PARTS & SERVICE NEWS

AH04511

SUBJECT: Swing gear GFB 174E 9012**PURPOSE:** Increasing of the lifetime by using of new kind of bearings (C2)**APPLICATION:** H 485 (12004; 12008; 12023; 12024);
H 655S (12025-027; 12031-32; 12034);
PC8000-1 (12028-29; 12033; 12035-36)**FAILURE CODE:** 261CDJ**DESCRIPTION:**

GFB 174E 9012 (PN 654 454 40)

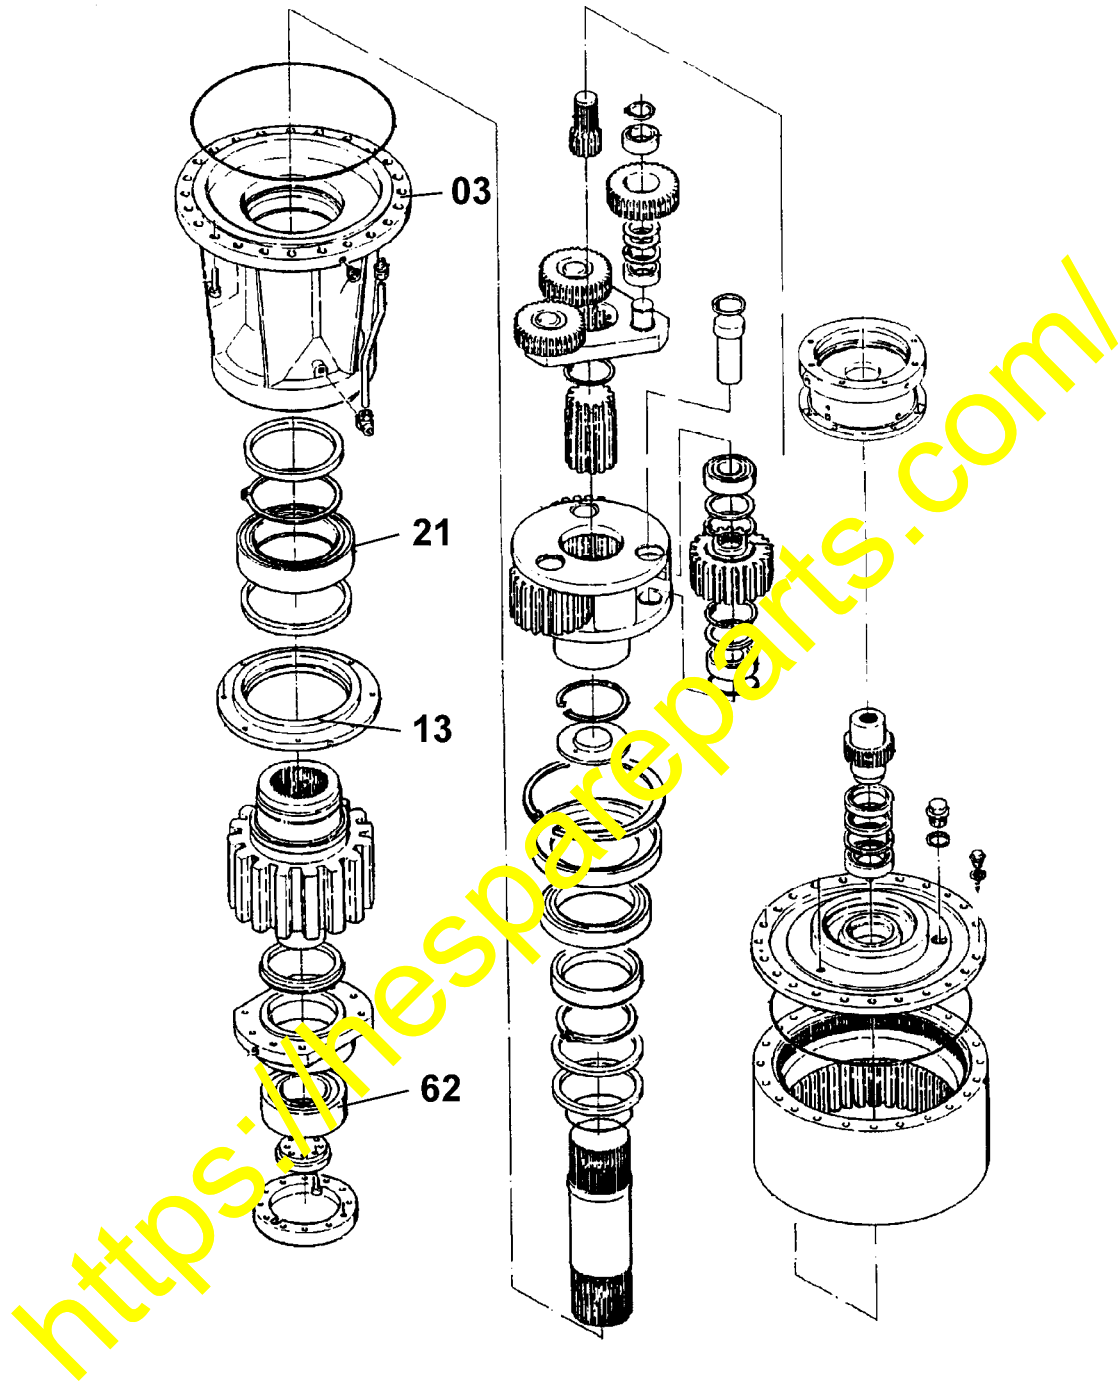
- During a complete overhaul of the swing gear the bearings (21 and 62 – refer to drawing next page) should be changed to the new type (C2).
- Refer also Service Bulletin AH03524 – “Modification of the swing brake”.

For using new roller bearings (21; 62) the Sealing Cover (13) and the Axle Tube (03) have to be remachined according to the drawings on pages 3 and 4.

Sealing cover Pos. 13

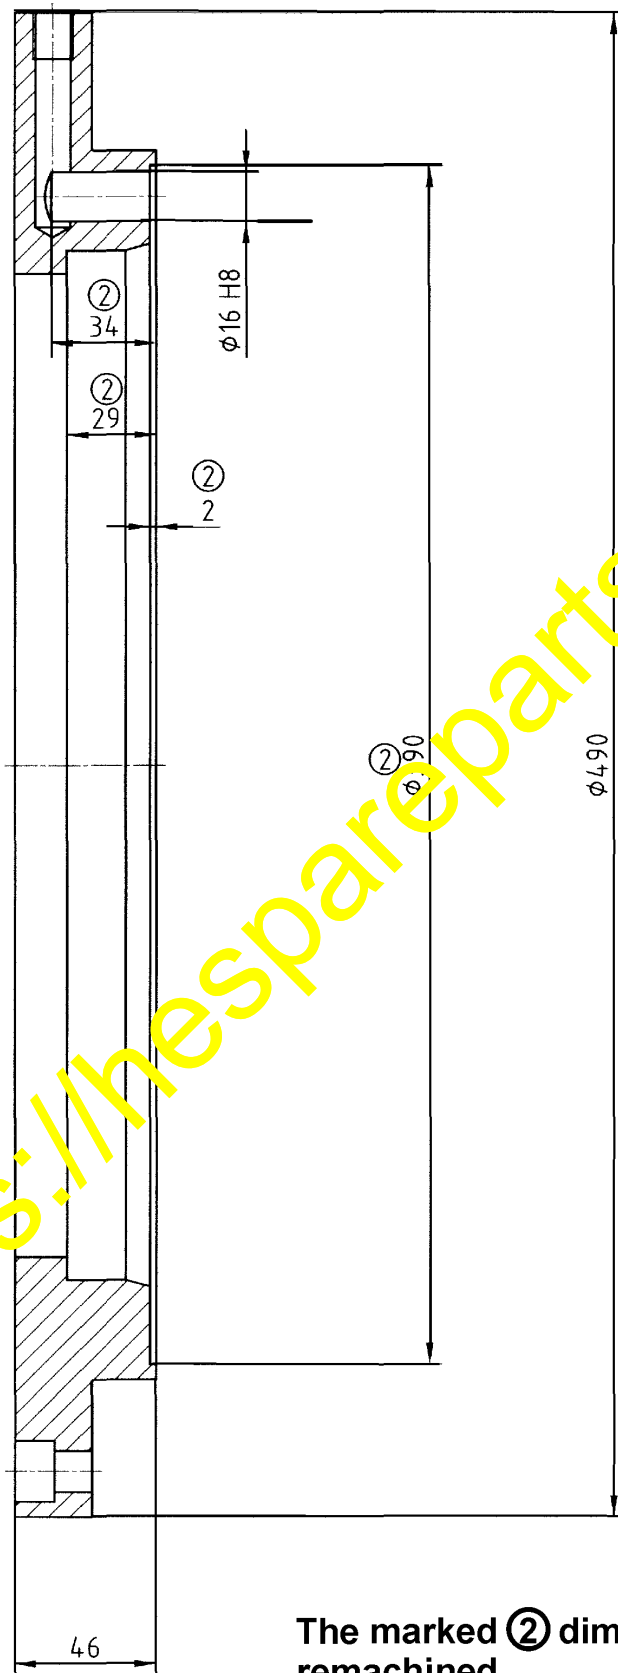
The marked ② dimensions have to be remachined

Axle tube Pos. 03

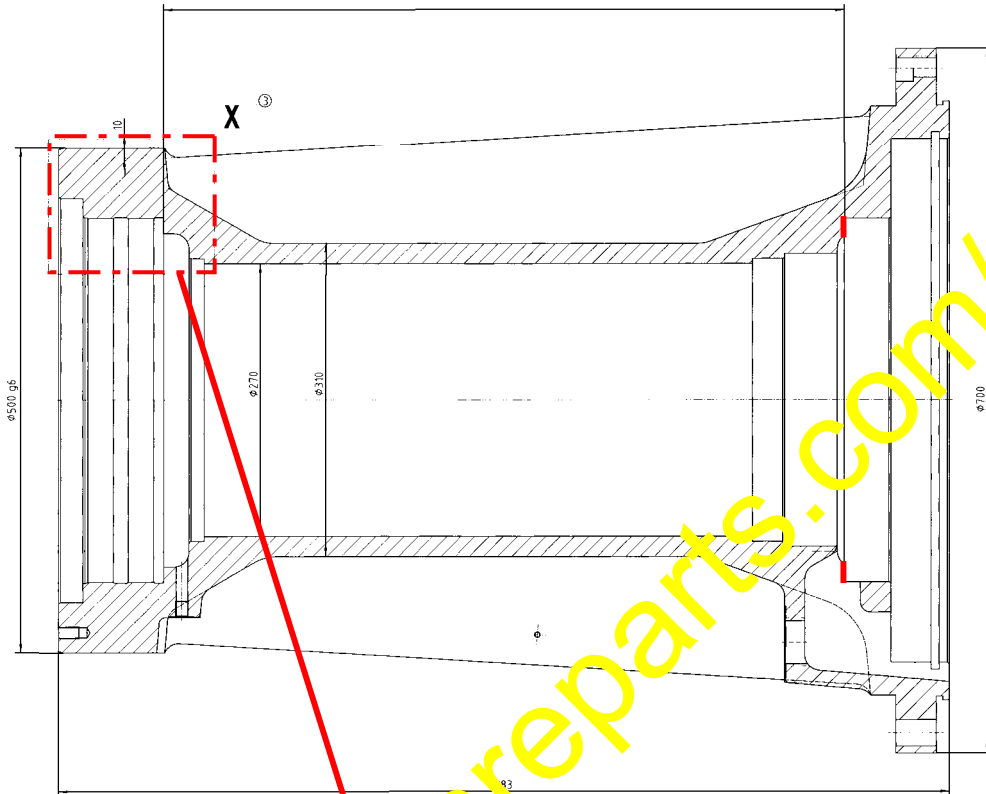
675±0.5 (Dimension have to be remachined)

Detail X ③

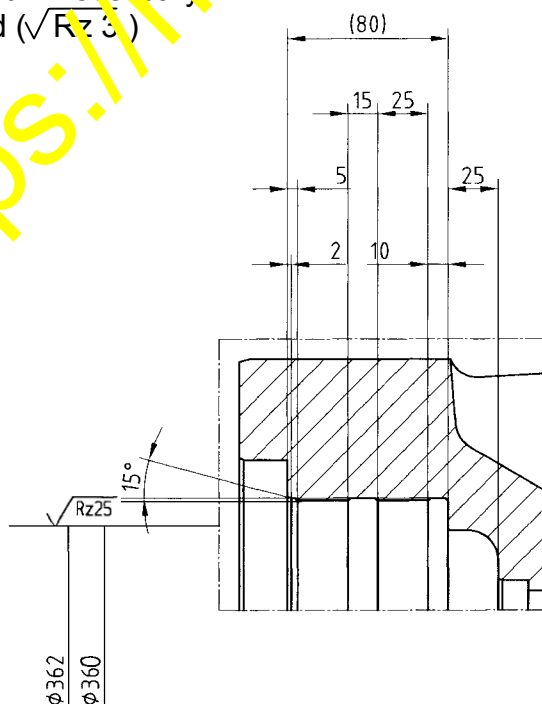
All dimensions have to be checked and if necessary remachined ($\sqrt{Rz 3}$)
